MCE - HYAC

Addendum #5

TOWN OF NEWTON CH BOOTH

OPTION 3

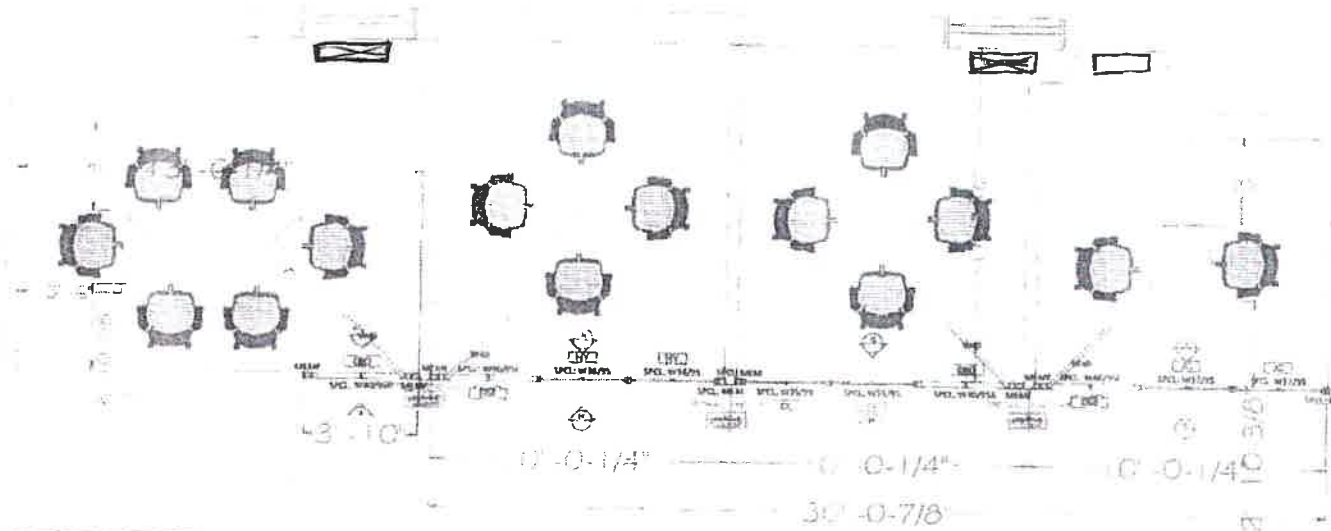
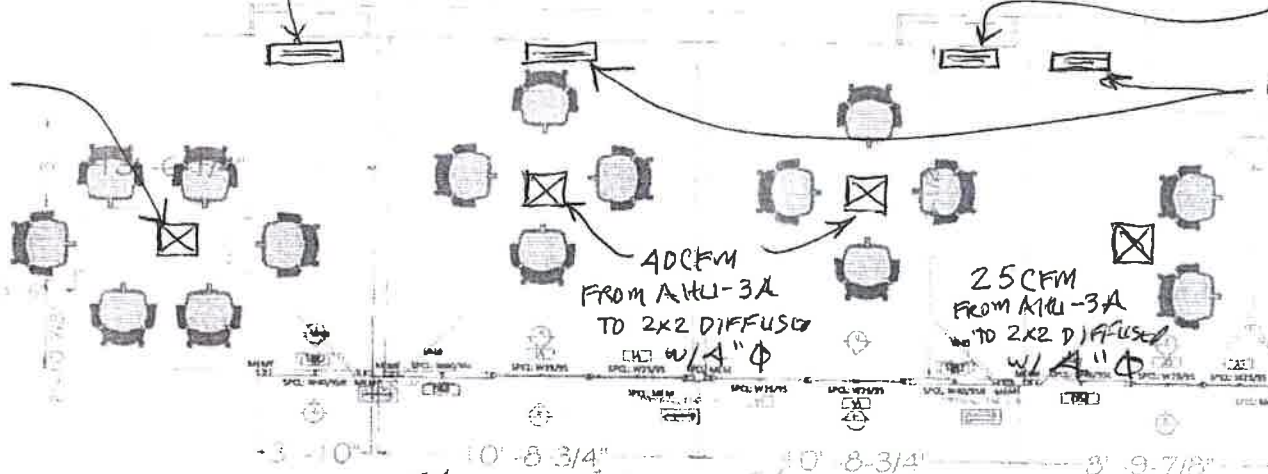
BASED CONSOLE UNIT AS PART OF INITIAL BID

55CFM
FROM
AHU-3A
TO
2x2
DIFFUSER
DUCT SIZE
TO BE 5"φ

NEW CONSOLE
LIMITS
CASED
& CONNECTED
TO HP-8

40CFM
FROM AHU-3A
TO 2x2 DIFFUSER
w/ 4"φ

25CFM
FROM AHU-3A
TO 2x2 DIFFUSER
w/ 4"φ

Changed to 10'-6" Changed

Changed - 9'

option 4 approved JUN 2/28/24
